**Re: File Number 08-52-0104-P, Humboldt Mill Joint Permit Application for an Inland Lakes and Streams Permit, Kennecott Eagle Minerals Company**

In a letter dated January 7, 2009 a request for clarification/information was received from the Land and Water Management Division (LWMD) titled "Application Correction Request." In fulfillment of your request, please find attached, answers to your questions, additional engineering detail and supporting documentation.

Updated Figures 1-3, 2-1 and 2-5

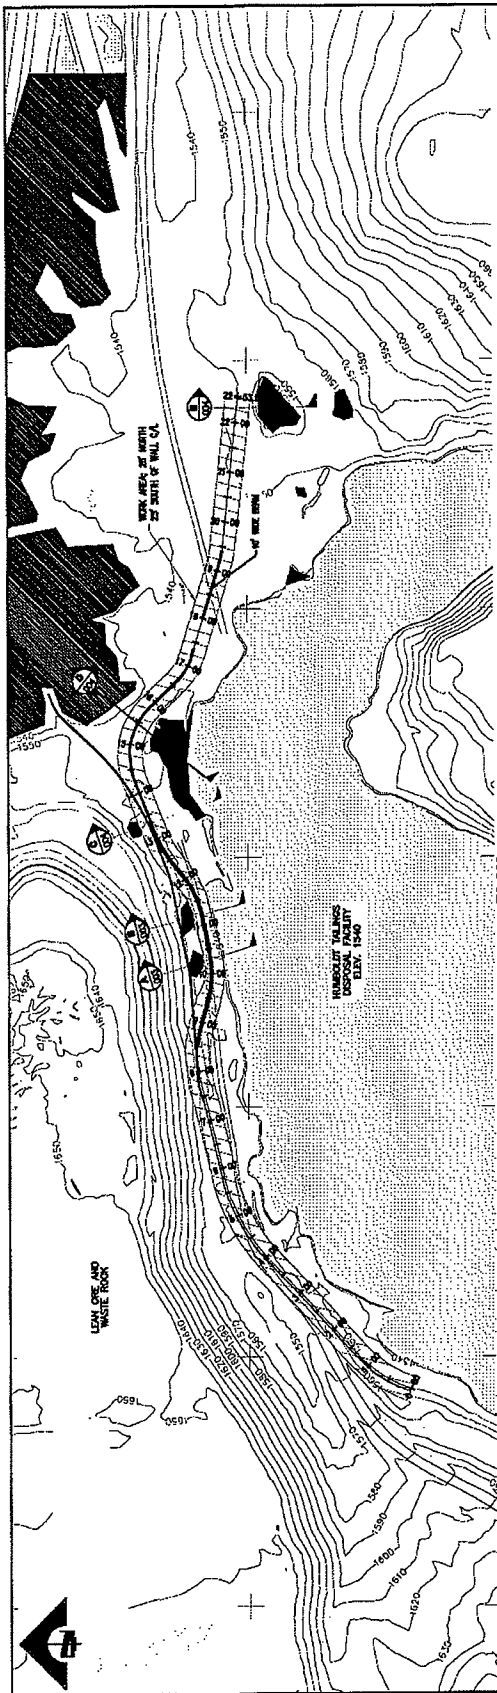
**2. Provide the pipe diameters and invert elevations in Section 10J**

**3. Provide a legible black and white 8 ½ x 11 copy of Figure 1-3 for public notice purposes.**

**5. On Figure 2-5 show the dimensions of the wall and berm.**

There was not enough space within section 10J to include the pipe diameters and elevations for all four intake and outlet pipes. This information has been included on Figures 1-3, 2-1 and 2-5 (Attachment C).

KEMC Response: A black and white 8 ½ x 11 copy of the revised Figure 1-3 is included within Attachment C.

KEMC Response: *Dimensions for the cutoff wall and berm have been added to Figure 2-5. An updated version of Figure 2-5 is included in Attachment C.*

New Cut Off Wall Figures 2-5a, 2-5b and 2-5c

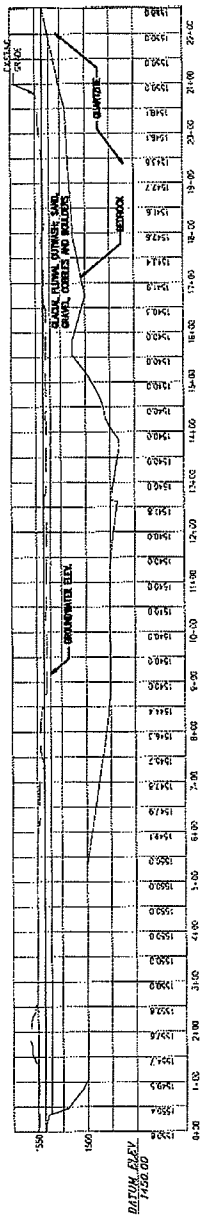
**6. Provide black and white cross sections of the cutoff wall / slurry wall and berm showing boundaries of adjacent wetland, width of work area, and structure dimensions. Include height, base and top widths of the berm. Indicate length of the proposed berm. Enclosed is a site plan for reference.**

KEMC Response: *Three new drawings have been attached which provide all the information requested in Question 6:*

- *Figure 2-5a Humboldt Tailings Disposal Facility Civil Cut Off Wall*
- *Figure 2-5b Humboldt Tailings Disposal Facility Civil Cut Off Wall Civil Sections 1*
- *Figure 2-5c Humboldt Tailings Disposal Facility Civil Cut Off Wall Civil Sections 2*

*Figure 2-5a shows the cutoff wall and berm details in detail, profile and plan view, Figure 2-5b provides information for Sections A-A' and B-B' and Figure 2-5c contains Sections C-C', D-D' and E-E'. Copies of all three new figures are contained in Attachment D.*

Updated/New Figure 2-6a and Figure 2-6b

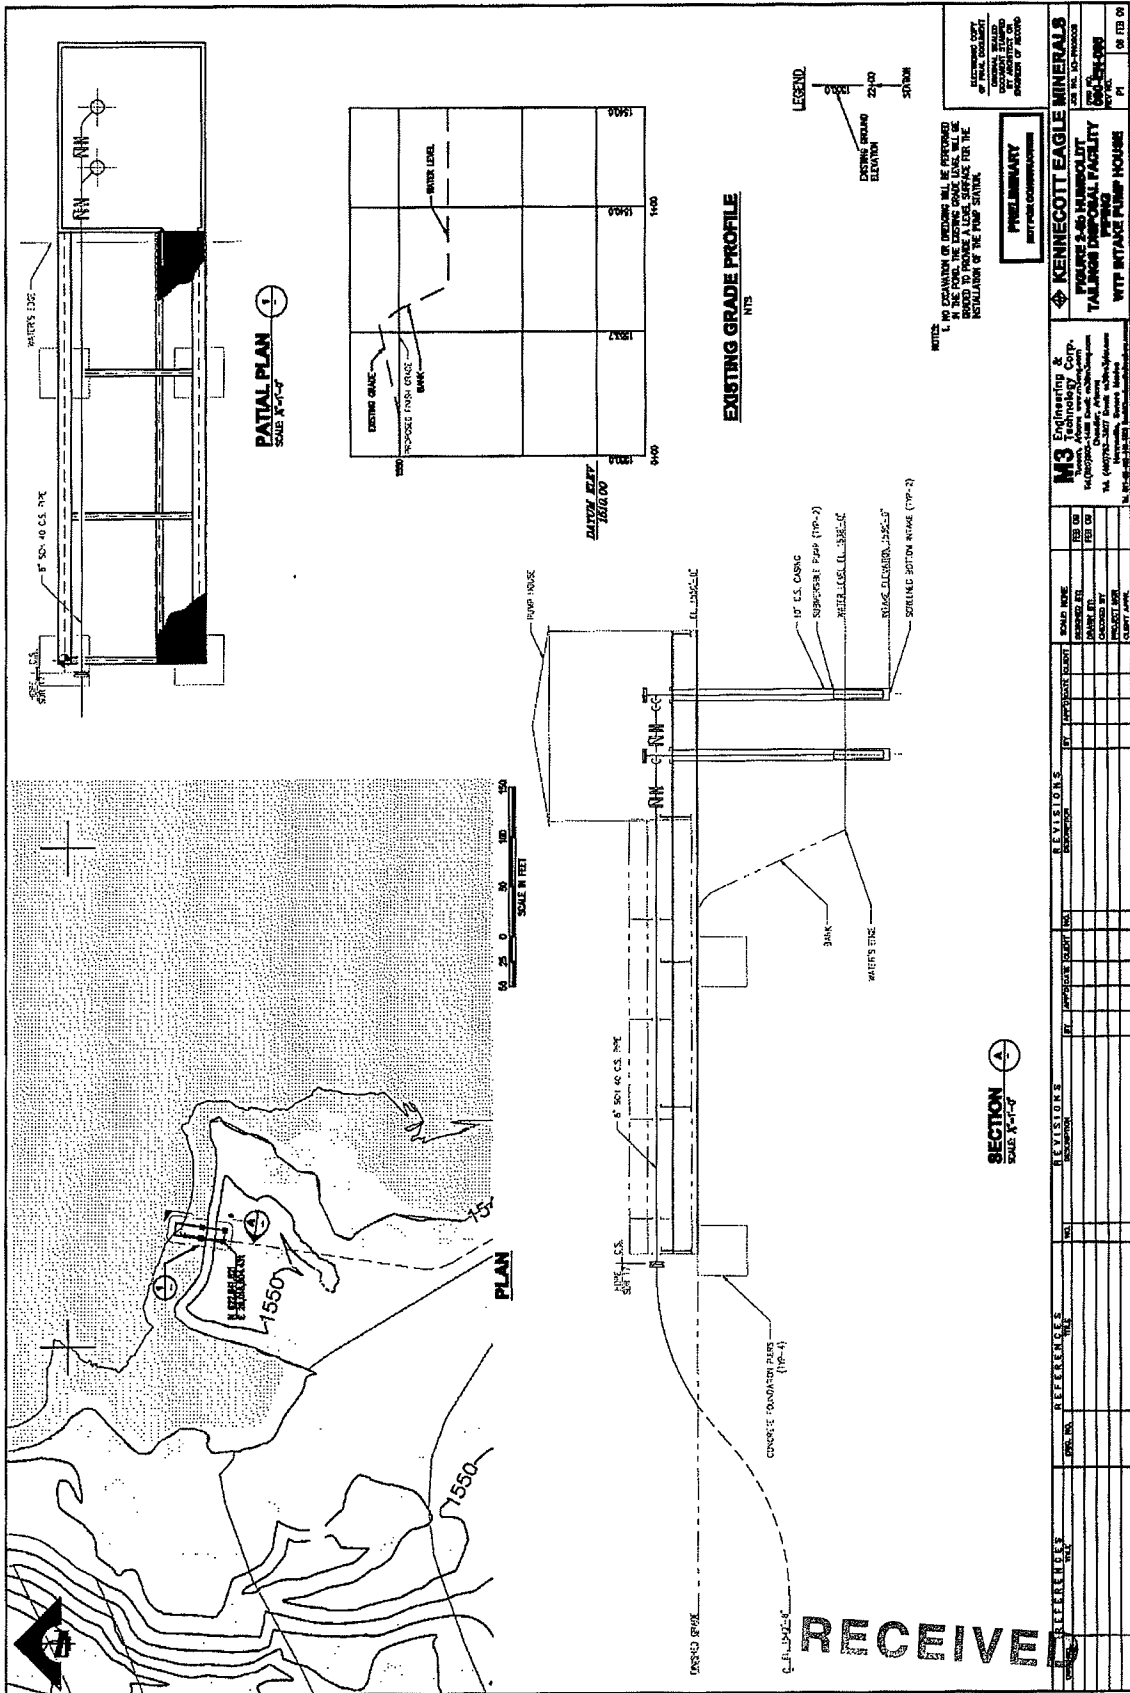
**7. Provide a site specific profile and cross section of the stationary water intake structure showing**

- a. The waters edge
- b. Location, elevation and dimensions of the proposed structure
- c. Location and dimensions of proposed excavation/dredge and/or fill areas
- d. Location and dimensions of excavation/dredge spoil areas
- e. Existing and proposed grades
- f. And cross section scale

**8. Provide a site specific profile and cross section of the outlet discharge into the wetland showing**

- a. Wetland edge/boundaries**
- b. Location, dimensions and discharge elevation of the proposed structure**
- c. Location and dimensions of proposed excavation/dredge and/or fill areas**
- d. Location and dimensions of excavation/dredge spoil areas**
- e. Existing and proposed grades**
- f. And cross section scale**

KEMC Response: *Updated drawings of Figure 2-6 have been created consistent with the sample drawing provided in your January 7, 2009 letter. Please replace the original Figure 2-6 with Figure 2-6a and Figure 2-6b showing the stationary water intake*

*structure and the outlet discharge into the wetland. Figures 2-6a and 2-6b are contained within Attachment E.*

*Figure 2-6b shows the waters edge of the HTDF, location, elevation and dimensions of the intake structure, grades and a cross section scale. Items 7c and 7d are not applicable since dredging, excavation, spoils or fill are not currently planned.*

KEMC Response: *Updated drawings of Figure 2-6 have been created consistent with the sample drawing provided in your January 7, 2009 letter. Please replace the original Figure 2-6 with Figure 2-6a and Figure 2-6b showing the stationary water intake structure and the outlet discharge into the wetland. Figures 2-6a and 2-6b are contained within Attachment E.*

*Figure 2-6a shows the wetland boundary/edge, location, dimensions and discharge elevation of the outlet structure, grades and a cross section scale. Items 8c and 8d are not applicable since dredging, excavation, spoils or fill are not currently planned.*

*Figure 2-6a also provides information for Section G-G' and F-F'.*
